PIPING ARRANGEMENT FOR MODIFICATION OF FOT (S) TO LSMGO TANK

DWG NO	DA700M001-3
TITLE	F.O FILLING AND TRANSFER SYSTEM
CONS. NO	3
PROJ. NO.	5268

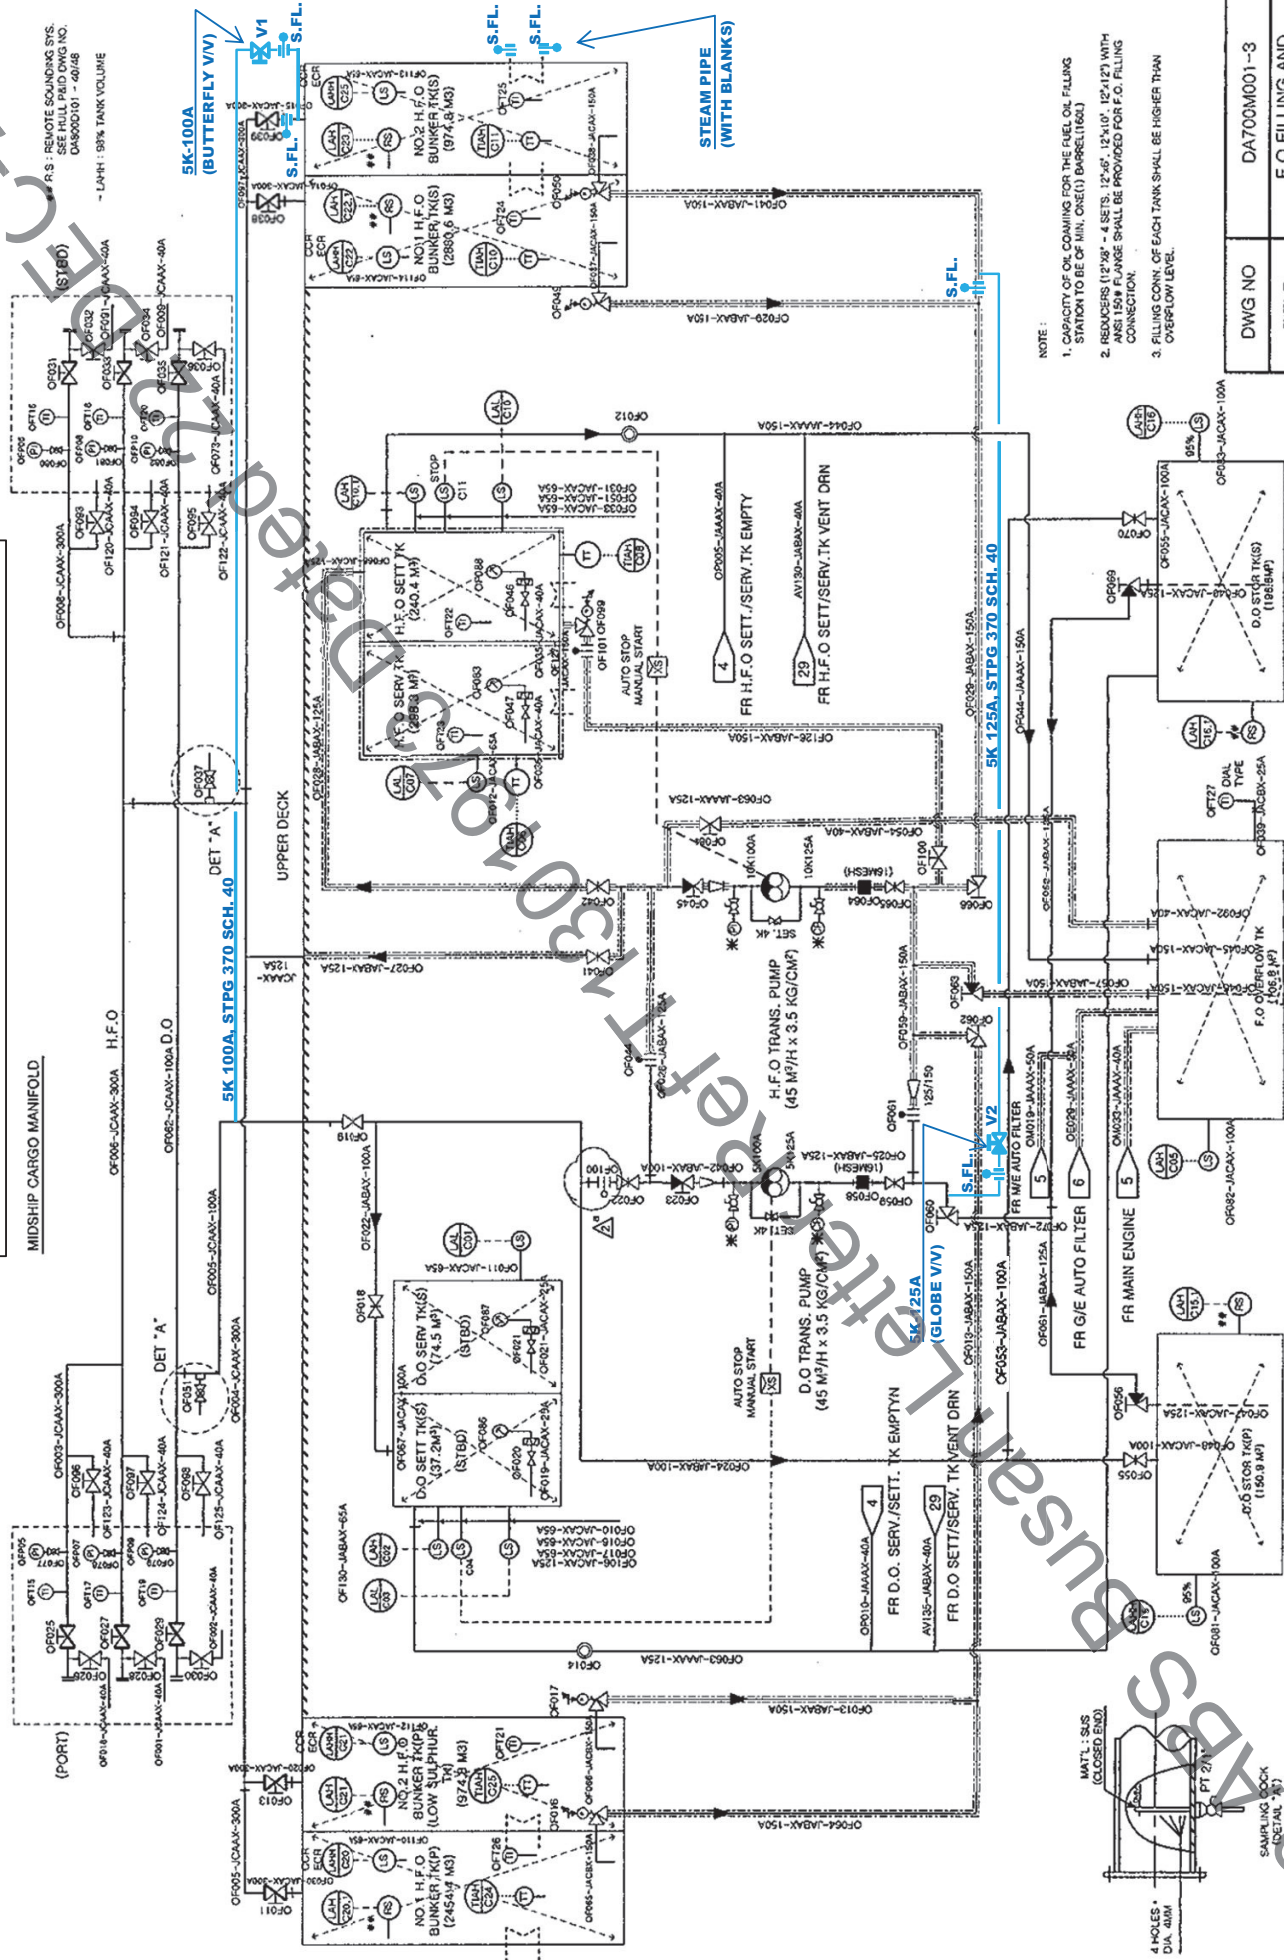
V1 - FILLING VALVE (MATERIAL // BODY: CAST IRON, DISC: BRONZE)
V2 - NON RETURN SUCTION VALVE FROM F.O.T. (S) (MATERIAL // BODY & DISC: BRONZE).
S.F.L. - SPECTACLE FLANGE
